**COUGAR CREEK
DEBRIS FLOOD RETENTION STRUCTURE**

**Supplemental Information Request Round 3
Water Act File No. 00384210
NRCB Application No. 1601**

SUBMITTED TO:
Alberta Environment and Parks
and Natural Resources Conservation Board

SUBMITTED BY:
Town of Canmore

Figure 1-1 United States Bureau of Reclamation Stilling Basin

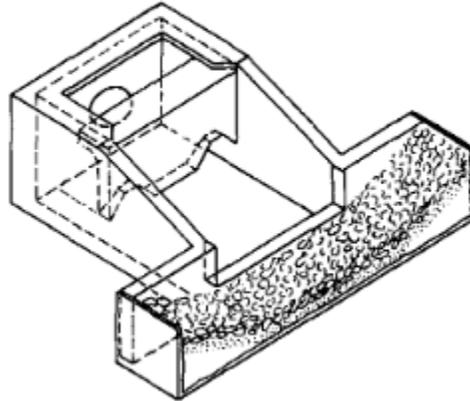
1	<p>Project Update, Section 1, Page 1</p> <p>The Project Update report describes that the Diversion Tunnel option will be included in the final project design for Flow Control. In the report the Town of Canmore states <i>Both of these options were described in Section 4.4 of the EIA report and were included in the assessment.</i> Section 4.4.4.3 (Page 4-25) of the EIA report describes the Flow Control options. However, the maximum design discharge from the Diversion Tunnel outlet at full impoundment, details on inlet and outlet erosion and scour protection are not mentioned in the EIA report for Diversion Tunnel option.</p> <ol style="list-style-type: none"> a. Provide the maximum design discharge from the Diversion Tunnel outlet at full impoundment. b. Provide a description of the inlet and outlet structures for this option. c. Explain if there is any Debris Rake designed for the Diversion Tunnel inlet. If not, explain how the debris will be captured. d. Explain if any modelling and analysis were done for the Diversion Tunnel option to understand the bank erosion and bed scour potential at and around the tunnel inlet and outlet. e. Explain if there is any bank erosion protection and bed scour protection designed for the tunnel inlet and outlet locations.

The tunnel outlet structure is quite different than the BOS outlet. The outlet structure of the BOS was within the stilling basin, providing the required energy dissipation. The outlet structure of the tunnel is now separate from the stilling basin and requires its own energy dissipator. The outlet design is based on the United States Bureau of Reclamation stilling basin for pipe or open channel outlets (Basin VI) shown in Figure 1 (USBR 1984). It has been modified to account for high amounts of gravel transport and clean-out requirements. At regular low flow, minimal energy dissipation occurs and gravel discharge is prioritized. However, at higher flows, the two rows of removable horizontal baffles provides the energy dissipation required. Extensive computational fluid dynamics (CFD) modelling has been

performed on the structure to optimize it and ensure that it meets the required discharge performance. A new physical scale modelling is being conducted by Northwest Hydraulic Consultants that focuses on the study and optimization of the spillway, stilling basin, and tunnel outlet.
